San Francisquito Creek – Stakeholder Meeting July 28, 2014

SF Creek: Meetings and Communications Involving the Water Board since Initial Application for Certification (BHW – 6/25/14)

**SAN FRANCISQUITO CREEK
 FLOOD REDUCTION, ECOSYSTEM
 RESTORATION, & RECREATION PROJECT**

**Subject: Application for Water Quality Certification for San Francisquito Creek Project,
Santa Clara and San Mateo Counties**

Existing versus Proposed Project Alternatives

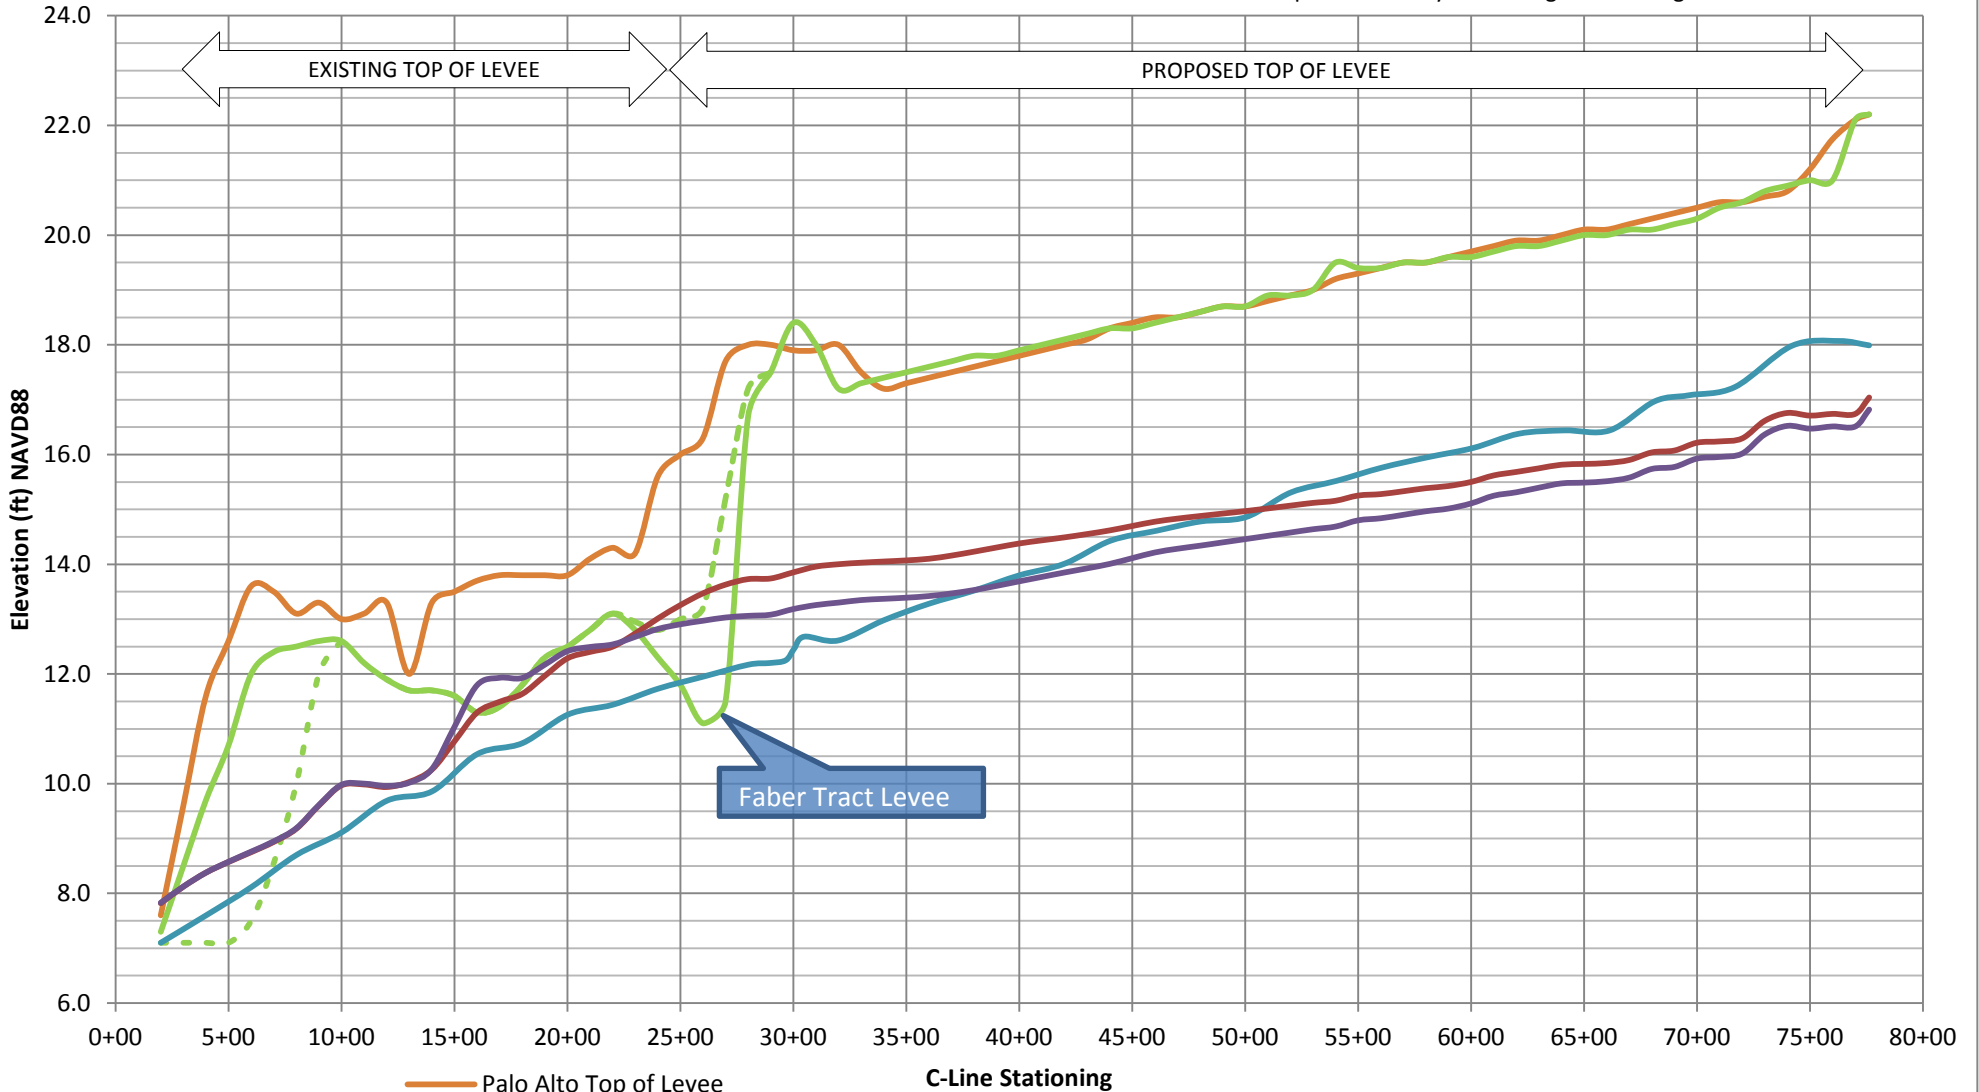
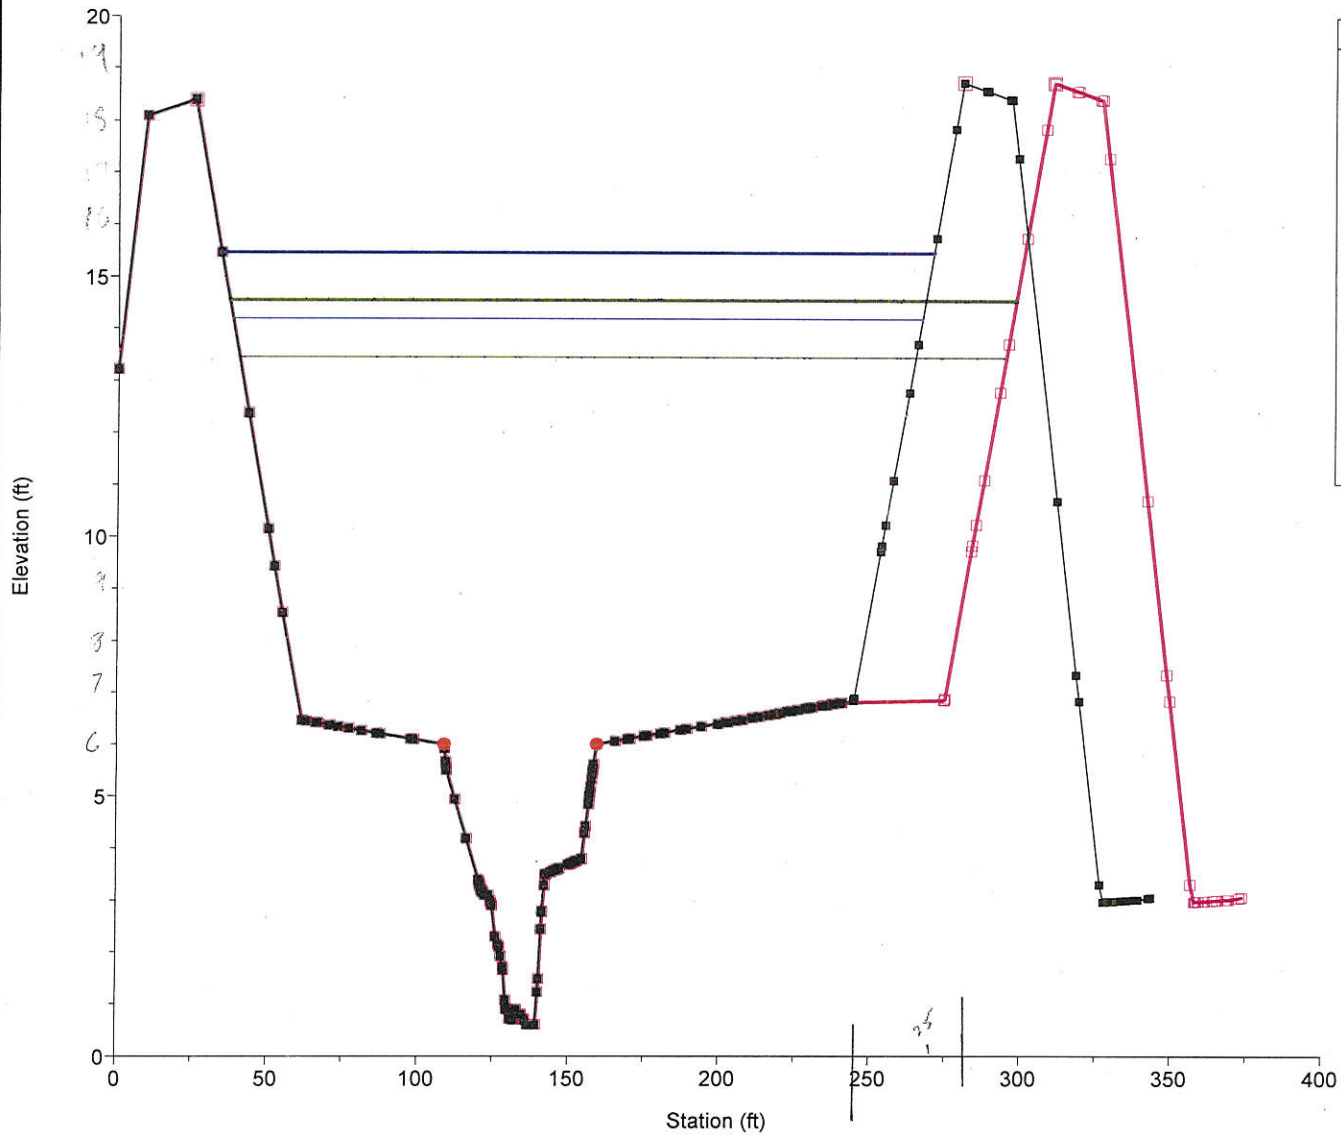
7400 cfs at 7.1' Tidal Event (MHHW)

Flows into Faber Tract

Existing Conditions = 155 cfs

FT Levee Raise Optimized + Bay Levee Degraded = 85 cfs

FT Levee Raise Optimized + Bay Levee Degraded + Larger Setback = 105 cfs

Flows into Neighborhoods

Existing Conditions = 2205 cfs

FT Levee Raise Optimized + Bay Levee Degraded = 0 cfs

FT Levee Raise Optimized + Bay Levee Degraded + Larger Setback = 0 cfs

SFCreek_FT_HDR_060614 Plan: 1) NoOvrt_SFDEg 2) LARGER Setback

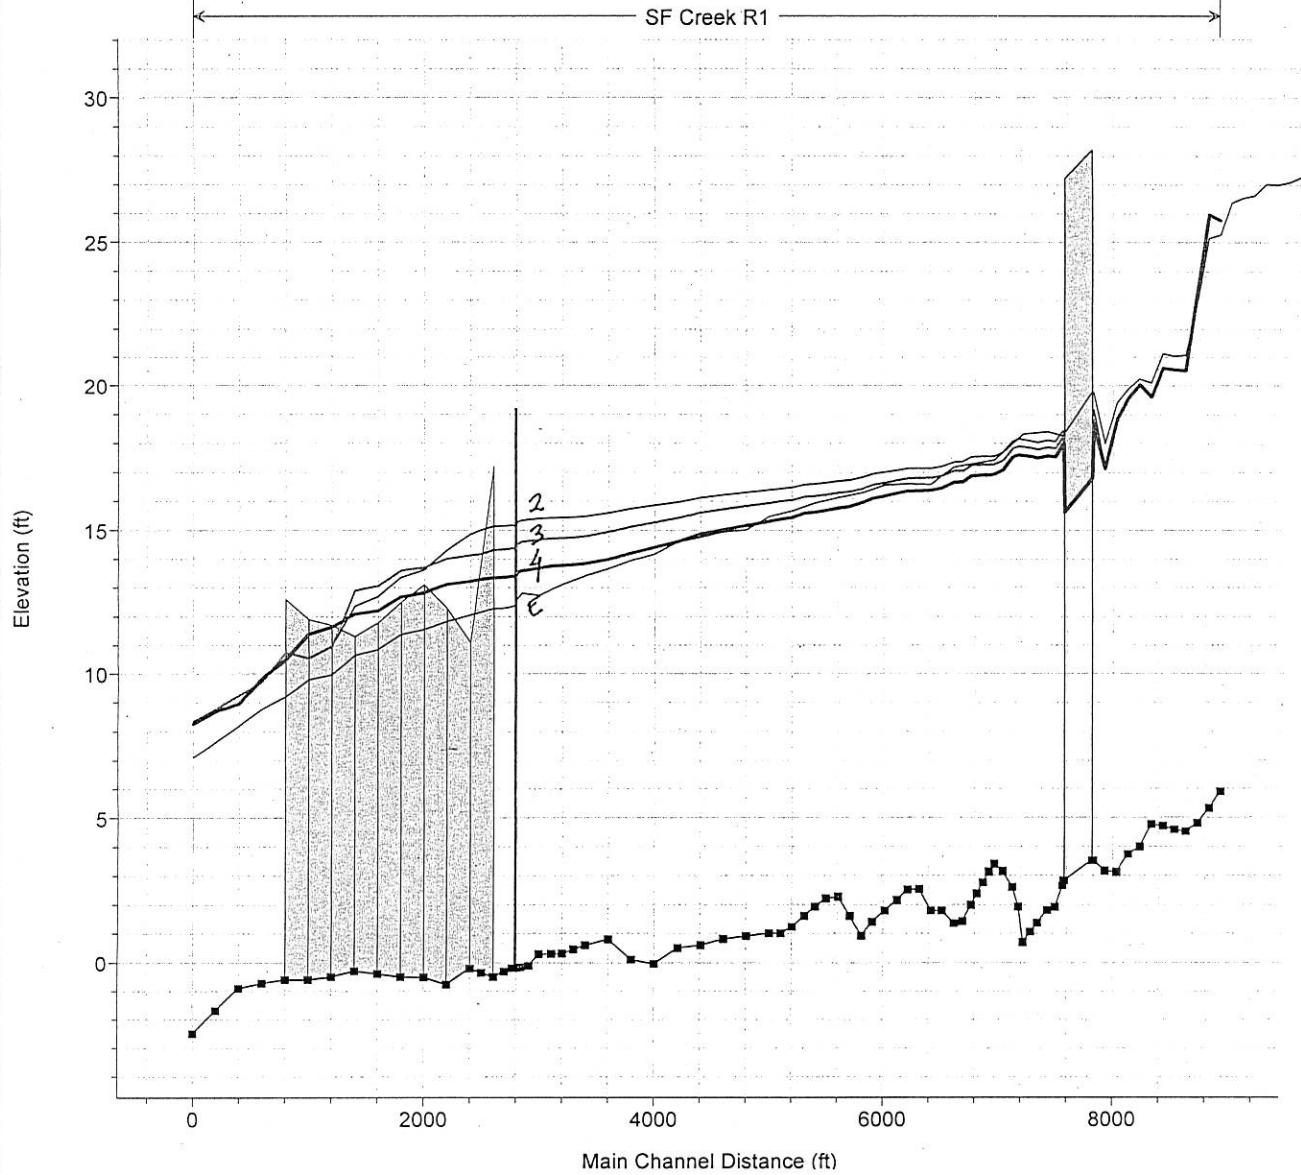
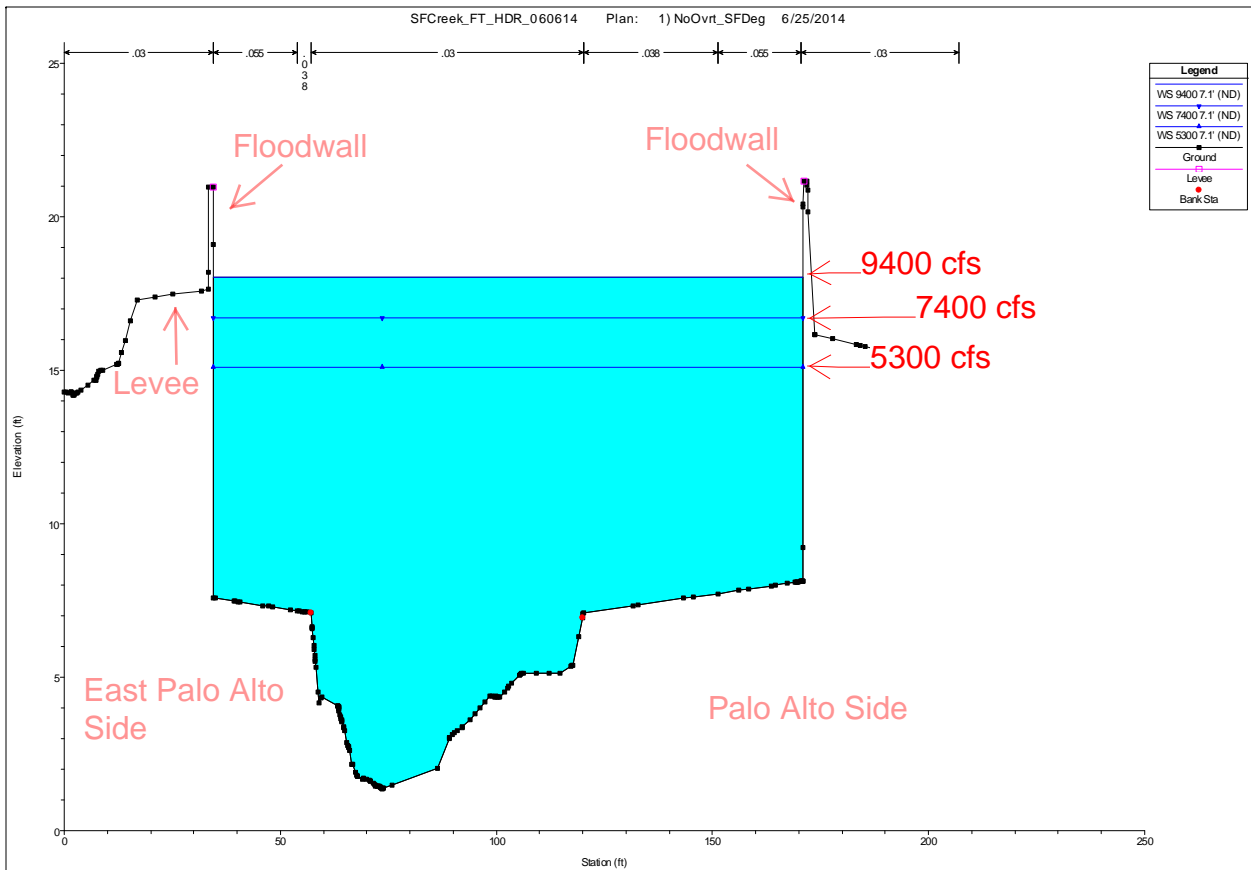
"E" Existing – Doesn't include new Hwy 101 culvert to go in this summer

- 2. Faber track berm filled in and triangle parcel flair
- 3. Faber Tract berm filled in, triangle parcel flair, and partial levee setback
- 4. Faber Tract berm filled in and levee setback

San Francisquito Cross-Section

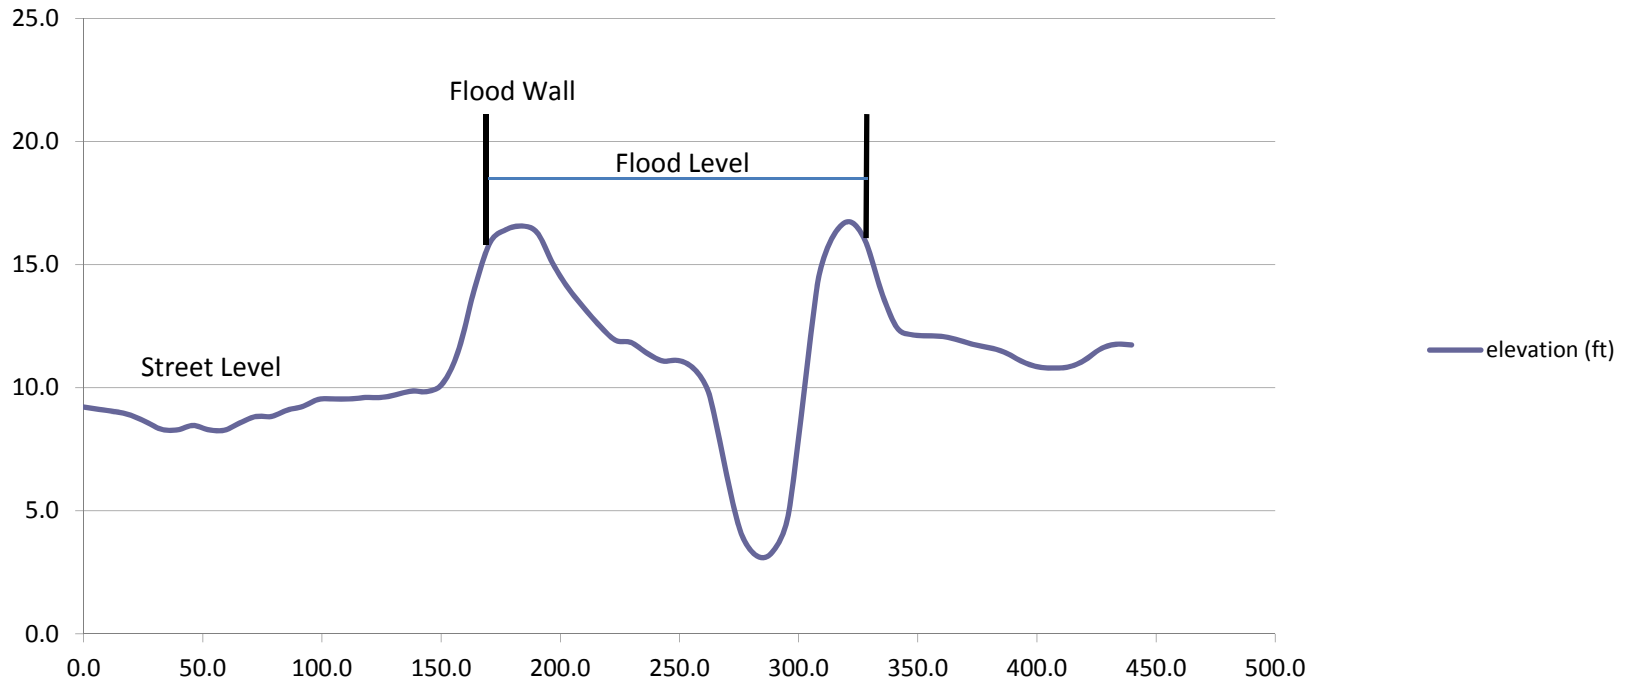
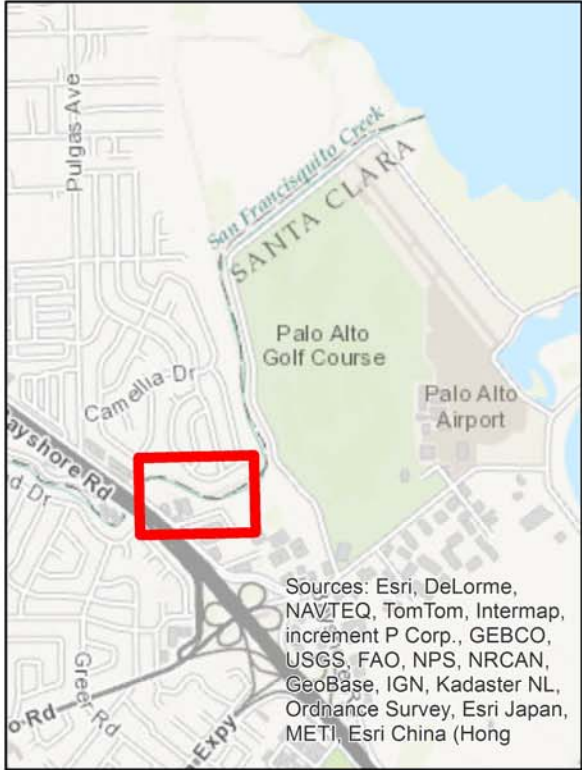
Location of lidar-derived cross section: San Francisquito Creek
